Access Compliance Report

Public Rights-of-Way

(Curb Ramps)

Intersection ID: 16794	Main Street: Highbrook_DR	Cross Street: Idlewild_RD	Location: SE
ADA ID: 88044D2C012B	Ramp Type: PerpDiag	Initial Pass/Fail: Fail	Overall Compliance: No
Severity Score: 13.75			
Codes/Mitigation Info/Possible Solution		Field Measurements/Component Compliance

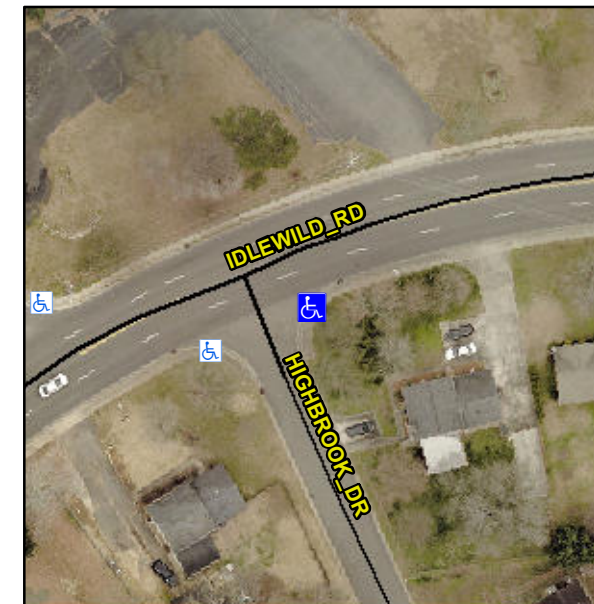
Not Found, R304.2.2, R304.5.3

Compliance	Description	Data	Compliance	Description	Data
N/A	Ramp Length (in)	60.0	No	Ramp Slope (%)	8.5
Yes	Ramp Width (in)	48.0	No	Ramp XSlope (%)	3.3
N/A	Flare Type LT	N/A	N/A	Flare Type RT	N/A
N/A	Flare Slope LT (%)	N/A	N/A	Flare Slope RT (%)	N/A
N/A	Flare Traversable LT?	N/A	N/A	Flare Traversable RT?	N/A
N/A	Landing Length (in)	N/A	N/A	DWS Provided?	N/A
N/A	Landing Width (in)	N/A	N/A	DWS Contrast?	N/A
N/A	Landing Slope (%)	N/A	N/A	DWS Length (in)	N/A
N/A	Landing X Slope (%)	N/A	N/A	DWS Full Width?	N/A
N/A	Landing Curb? (Y/N)	N/A	N/A	DWS Offset (in)	N/A
N/A	Shared Landing?	N/A			
N/A	Gutter Ponding?	N/A	N/A	Gutter Slope (%)	N/A
N/A	Gutter Lip Ht (in)	N/A	N/A	Gutter X Slope (%)	N/A
N/A	Painted X Walk1?	No	N/A	Painted X Walk2?	No
	X Walk 1 Direction	To N		X Walk 2 Direction	To W
N/A	X Walk 1 Width (in)	N/A	N/A	X Walk 2 Width (in)	N/A
	X Walk 1 Slope (%)	2.1		X Walk 2 Slope (%)	5.8
	X Walk 1 X Slope (%)	4.6		X Walk 2 X Slope (%)	0.4

N/A	Ramp inside XWalk1?	N/A	N/A	Ramp inside XWalk2?	N/A
	Road Slope (%)	4.0	N/A	Clear Space?	N/A
	Road X Slope (%)	2.0	N/A	Clear Space to XWalk (in)	N/A
N/A	Any Obstructions?	N/A	N/A	Storm Grate/Utility Hazard?	N/A
	Obstruction Type			Storm Grate/Utility Type	
		N/A			N/A
		Yes		Surface Condition? (G/P)	Good

Remove & Replace Curb Ramp With Two New Directional Ramps or Equivalent.
